## 10.4 Other Features of Steam and Power Conversion

The information in this section of the reference ABWR DCD, including all subsections, tables, and figures is incorporated by reference with the following departures and supplements.

**Figure 10.4-1 Main Condenser Evacuation System**

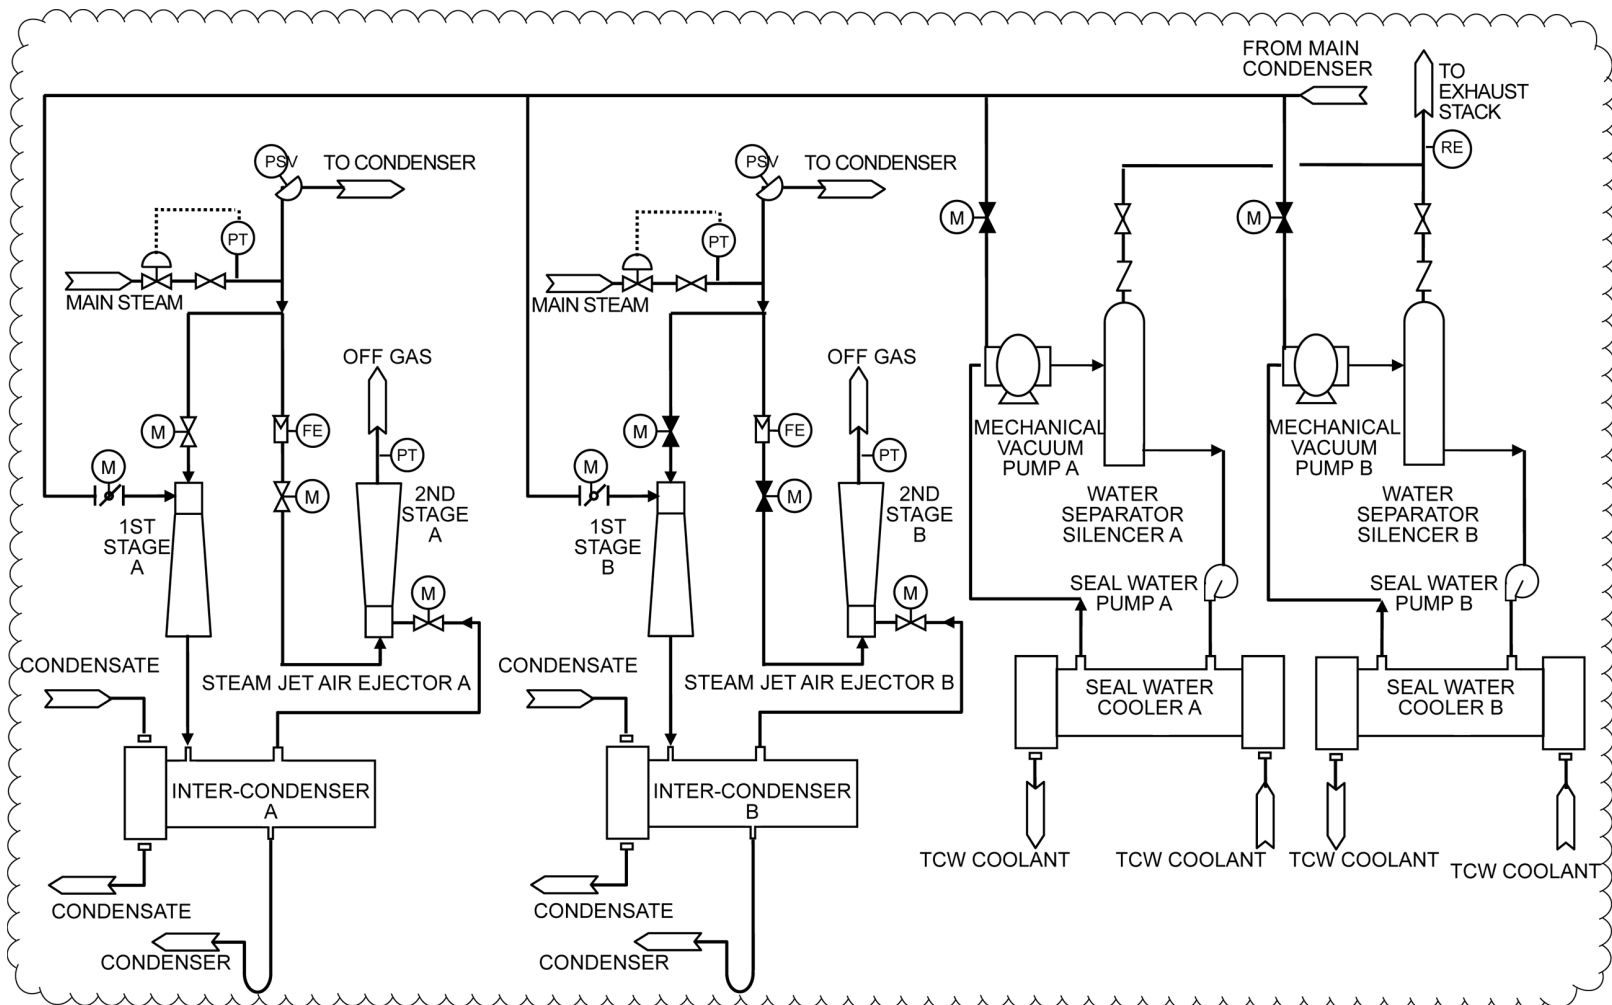
STP DEP 10.4-3 (Table 10.4-2, Figure 10.4-1)

The MCES (figure 10.4-1) consists of two 100%-capacity, double stage, steam jet air ejector (SJAE) units (complete with ~~intercondenser~~ intercondensers) for power plant operation, and ~~a two, 100% mechanical vacuum pump pumps~~ for use during startup. The last stage of the SJAE is a noncondensing stage. One SJAE unit is normally in operation and the other is on standby.

The SJAEs are placed in service to remove the gases from the main condenser after a pressure of about ~~0.034 to 0.051 MPa~~ 7kPa absolute or less is established in the main condenser by the mechanical vacuum pumps and when sufficient nuclear steam pressure is available.

Figure 10.4-2 Turbine Gland Seal System

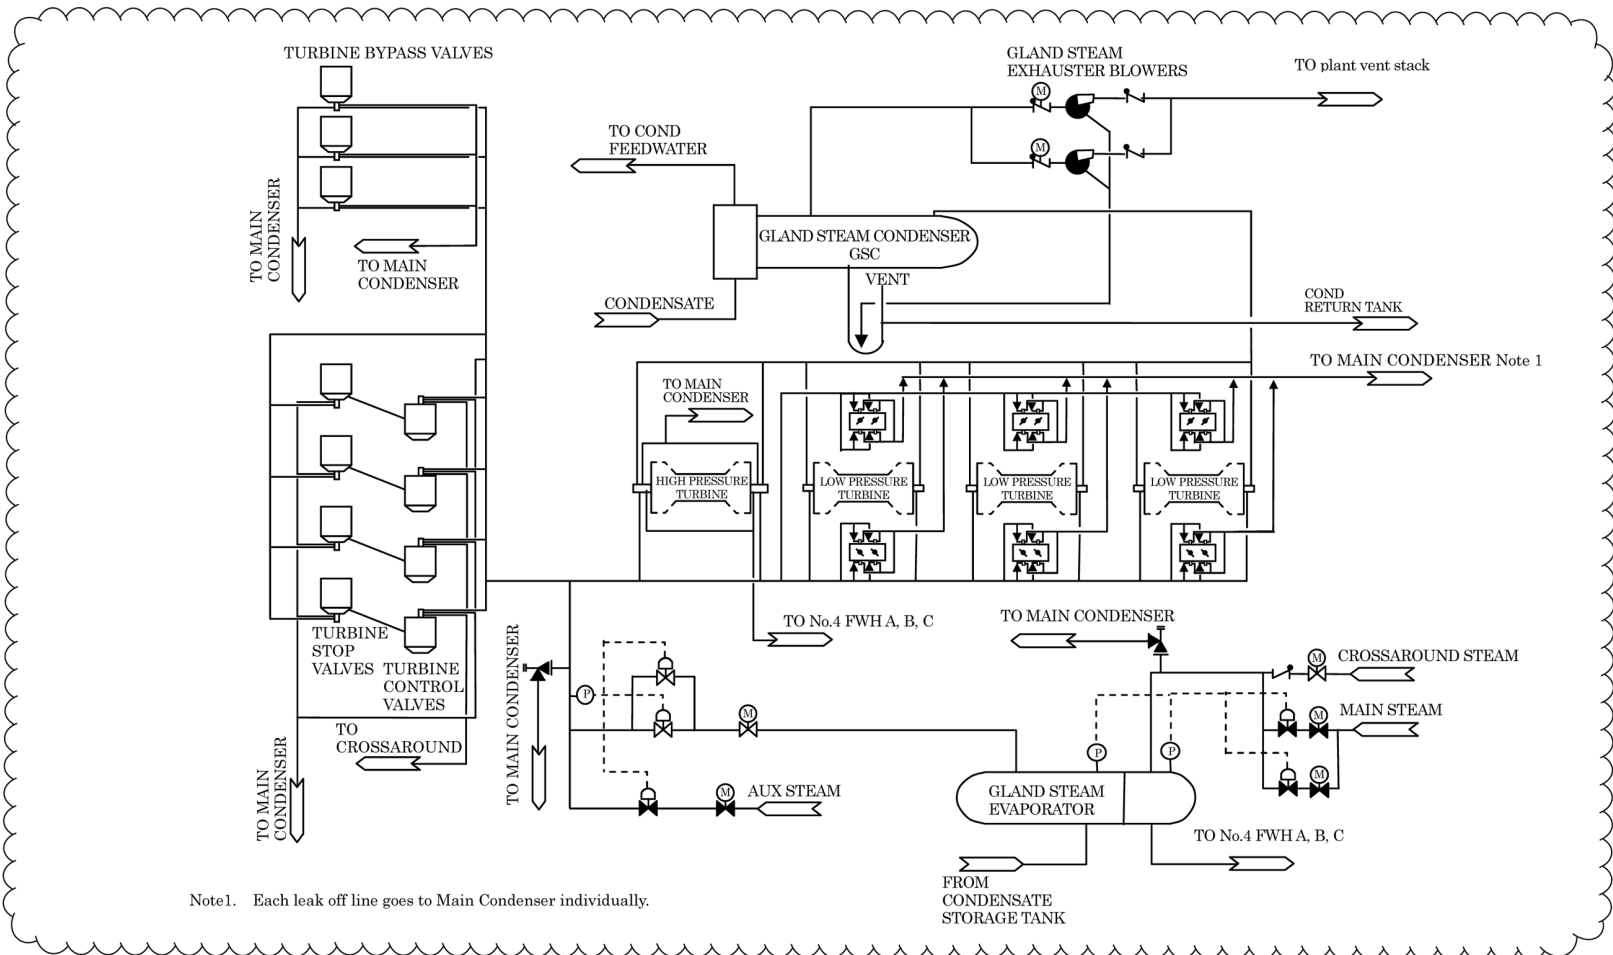
STD DEP 10.4-1 (Figure 10.4-2)

*The turbine gland seal system is illustrated in Figure 10.4-2. The turbine gland seal system consists of a gland steam evaporator, sealing steam pressure regulator, sealing steam header, a gland steam condenser with two full-capacity exhausters blowers, and the associated piping, valves and instrumentation.*

Figure 10.4-3 Circulating Water System

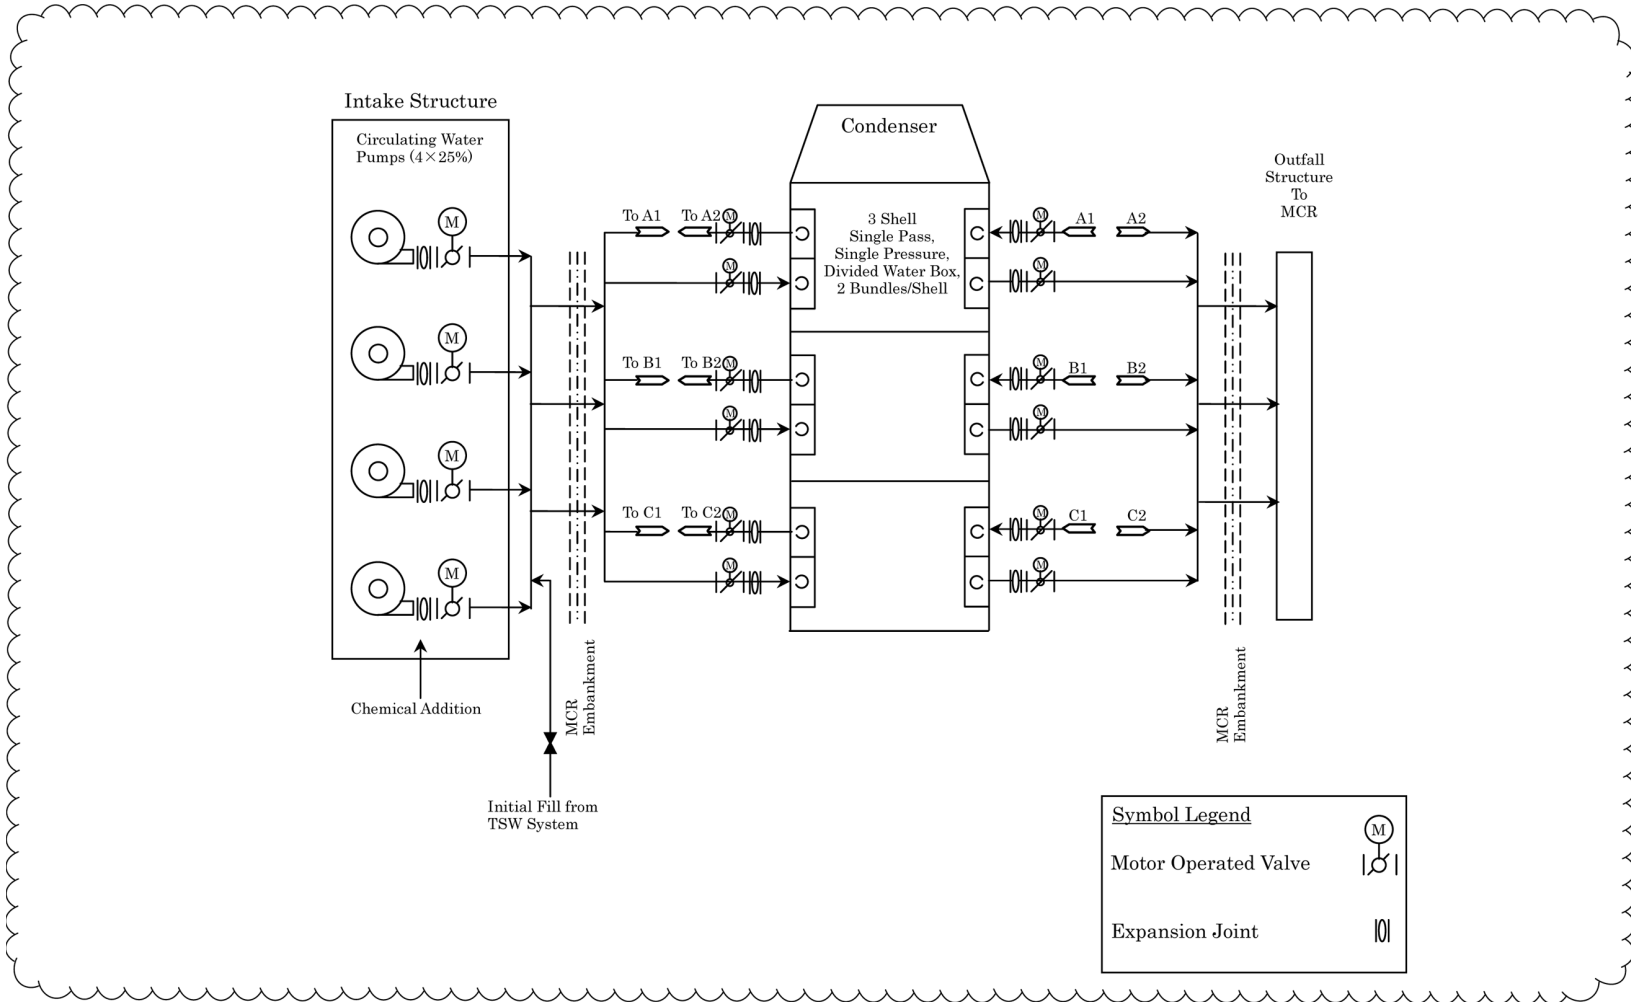
STP DEP 10.4-2 (Table 10.4-1, Table 10.4-3, Figure 10.4-3)

*~~The three condenser shells are designated as the low pressure shell, the intermediate pressure shell, and the high pressure shell. The three condenser shells are cross-connected to equalize pressure. Each shell has at least two tube bundles. Circulating water flows in series~~ parallel through the three single-pass shells (Figure 10.4-3).*

*The Circulating Water System (Figure 10.4-3) consists of the following components: (1) ~~screen house~~ intake structure and intake screens, pumps, (2) condenser water boxes and piping and valves, (3) tube side of the main condenser, (4) water box fill and drain subsystem, and (5) related support facilities such as for system water treatment, inventory blowdown and general maintenance.*

Four 25% capacity fixed speed circulating water pumps per unit discharge into a common header shown in Figure 10.4-3. The discharge of each pump is fitted with a motor operated butterfly valve. The circulating water is pumped through the main condenser and back to the MCR via a discharge outfall at a nominal rate of 272,550 m<sup>3</sup>/h per unit. To provide capability for condenser waterbox isolation, isolation valves are located on the circulating water inlet and outlet lines.

Figure 10.4-5 Condensate System

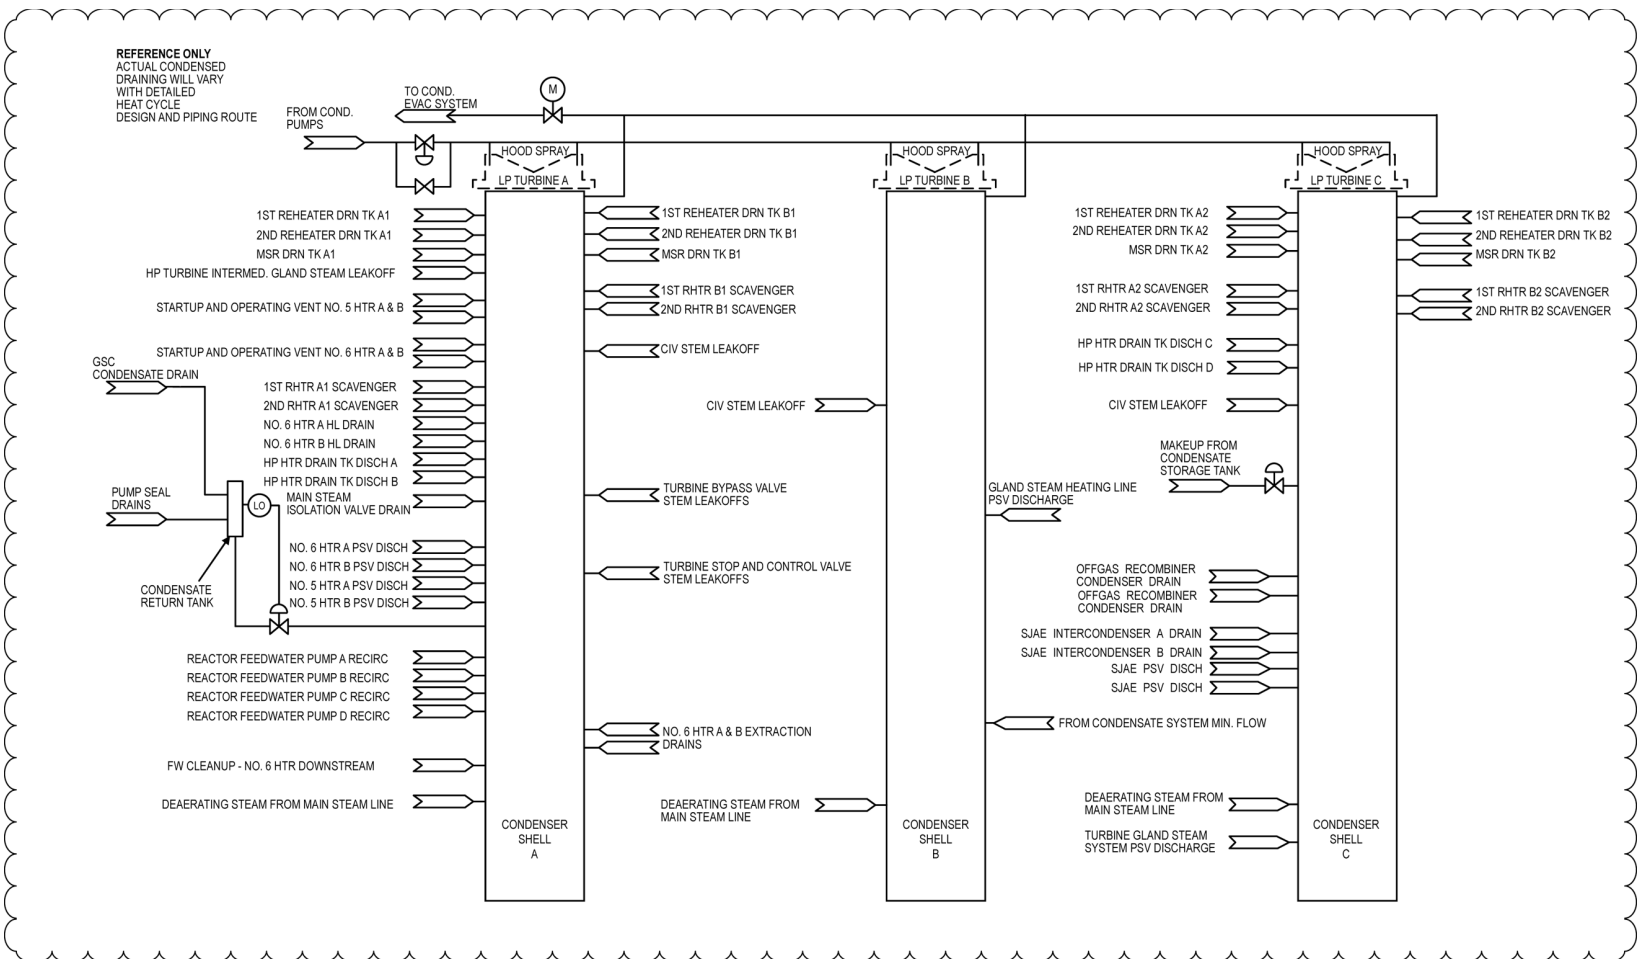
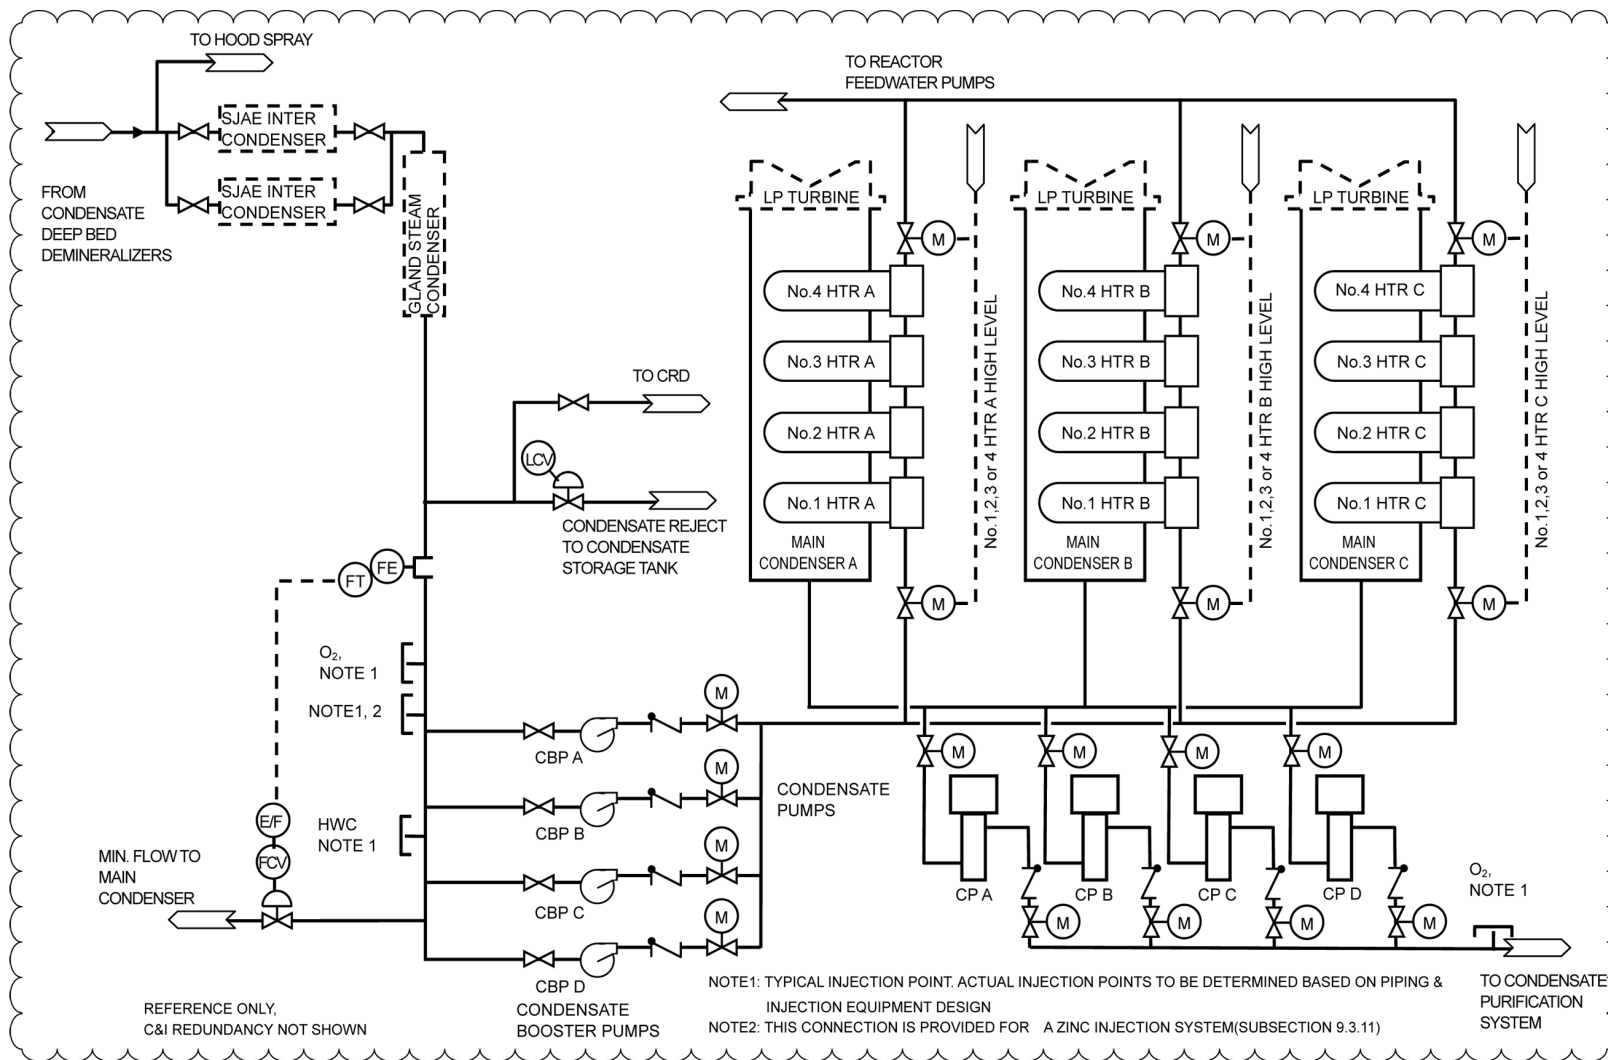
STD DEP 9.2-3 (Figure 10.4-5)

STD DEP 10.4-5 (Tables 10.4-4, 10.4-5 and 10.4-6, Figures 10.4-5, 10.4-6, 10.4-7, and 10.4-8)

*The Condensate and Feedwater System (Figures 10.4-5 and 10.4-6) consists of the piping, valves, pumps, heat exchangers, controls and instrumentation, and the associated equipment and subsystems which supply the reactor with heated feedwater in a closed steam cycle utilizing regenerative feedwater heating. The system described in this subsection extends from the main condenser outlet to (but not including) the seismic interface restraint outside of containment. The remainder of the system, extending from the restraint to the reactor, is described in Chapter 5. Turbine cycle steam is utilized for a total of six stages of closed feedwater heating. The drains from each stage of the low-pressure feedwater heaters are cascaded through successively lower pressure feedwater heaters except the lowest and second lowest pressure feedwater heaters which drain to the low pressure heater drain tanks for each string. The drains from each low pressure heater drain tank flow into the external drain coolers of each lowest pressure feedwater heater and finally to the main condenser. The high pressure heater drains are pumped backward to the reactor feedwater pumps suction. The cycle extraction steam, drains and vents systems are illustrated in Figures 10.4-7 and 10.4-8.*

*The CFS consists of four ~~33-50%~~ 33% capacity condensate pumps (three normally operating and one on automatic standby), four 33% capacity condensate booster pumps, (three normally operating and one on automatic standby). ~~three normally operated 33-65%~~ four 33% capacity reactor feedwater pumps (three normally operating, one on automatic standby), four stages of low-pressure feedwater heaters, and two stages of high- pressure feedwater heaters, piping, valves, and instrumentation. The condensate pumps take suction from the condenser hotwell and discharge the deaerated condensate into one common header which feeds the condensate filter/demineralizers. Downstream of the condensate demineralizers, the condensate is taken by a single header and flows ~~in parallel through five~~ through the auxiliary condenser/coolers, one gland steam exhauster condenser, and two sets of SJAE condensers, ~~offgas recombiner condenser (coolers).~~ The condensate then branches into three parallel strings of low pressure feedwater heaters. Each string*
